Historic District Commission Administrative Approval Application

RE: Request for HDC Administrative Approval for 553-559 Islington Street, Tax Map 157 / Lot 3

**553-559
ISLINGTON STREET
REDEVELOPMENT**

**HDC ADMINISTRATIVE
APPROVAL**

Hole in chimney, brick in poor condition

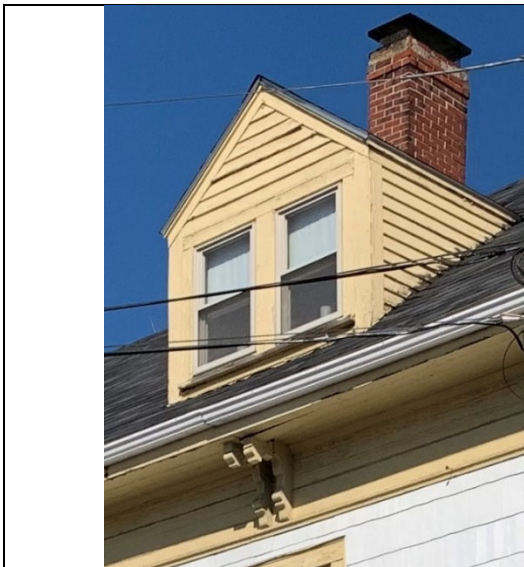
8/10	14. (1x) chimney removed.	Approval Requested - Objections noted
9/14	This chimney had been removed and capped a few inches above the ridge of the roof prior to the Owner's purchase of the building. During demolition of interior finishes, the brick was found to be in poor condition and there was a large hole in the chimney (see photo). Due to safety concerns the remaining chimney was removed down to the basement.	
10/5	HDC: Concerns were noted about removal of the capped chimney, but there seemed to be a consensus to accept removal.

Completed Portico

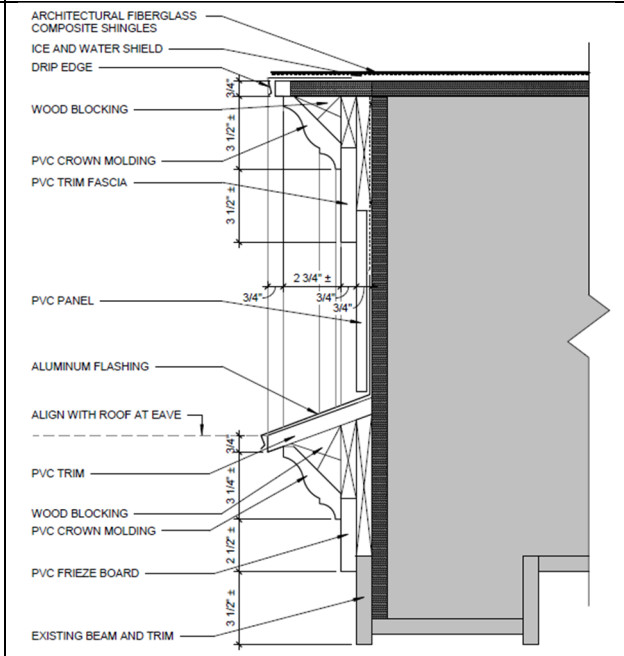
8/10	25. Portico design altered (e.g. omission of pilasters, changed to gable roof, column details altered).	Approval Requested - Objections noted
9/14	This design was revised to be consistent with the gables on the main addition and the reworked gable on the side addition.	
10/5	HDC: Noted concerns about the rear portico looking too modern and not referencing the style of the building.	
10/24	Additional trim is proposed to improve the appearance of the rear portico, by adding pilasters at the exterior wall, a cornice across the front of the gable, and replacing clapboards with paneling. Approval of the revised design is requested.

Completed deck – 17" +/- above grade

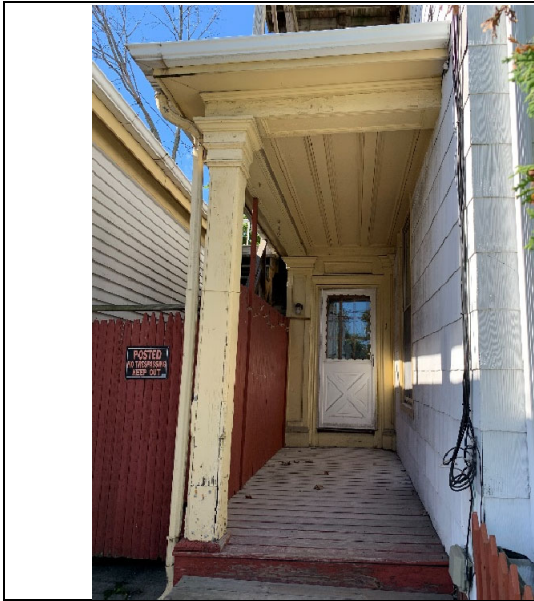
8/10	21. Ground level deck railings omitted.	Approval Requested - No objections
9/14	Railings had been proposed on the design drawings, however the original building did not have railings and this deck is only 17" +/- above grade, which does not require a guardrail by code.	
10/5	HDC: No objections noted.

Design drawing – Landing from side addition to avoid bulkhead

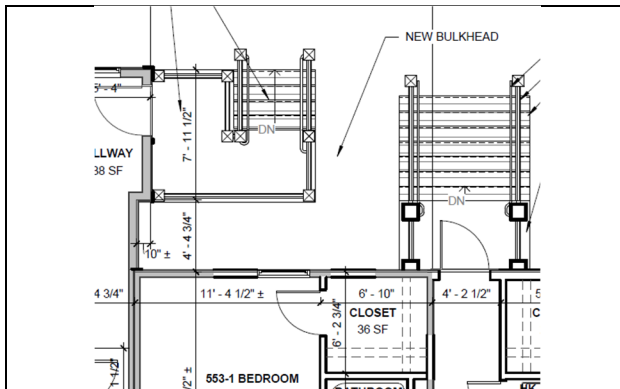
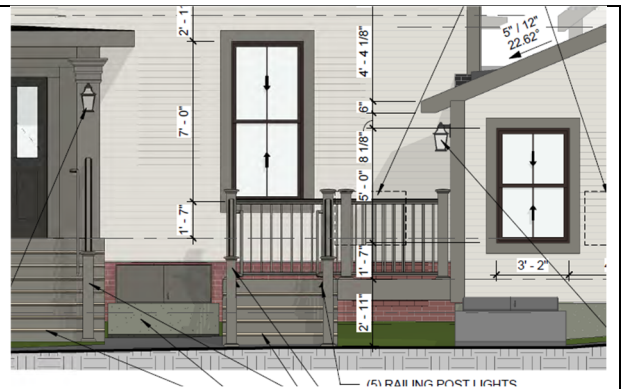
8/10	27. Deck omitted.	Approval Requested - No objections
9/14	The original design for the stair and landing at the rear of the side addition was configured to provide egress without blocking the bulkhead. During construction we determined that the other side of the portico was a better location for the bulkhead (2/12/21 Amended Site Plan Approval). This allowed this stair and landing to be simplified, and provides better privacy and security for the bedroom in the adjacent unit.	
10/5	HDC: No objections noted.

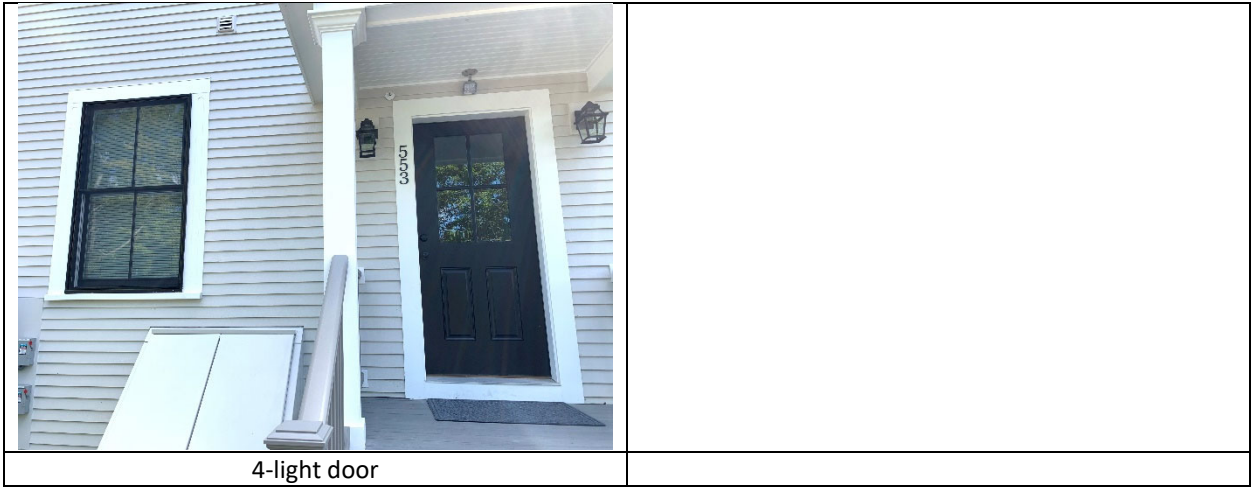
8/10	28. Portico door changed to 9 light.	Approval Requested - No objections
9/14	This is incorrect, this portico door is a 4-light (see photo). This is consistent with the appearance of the 2/2 windows.	
10/5	HDC: No objections noted.
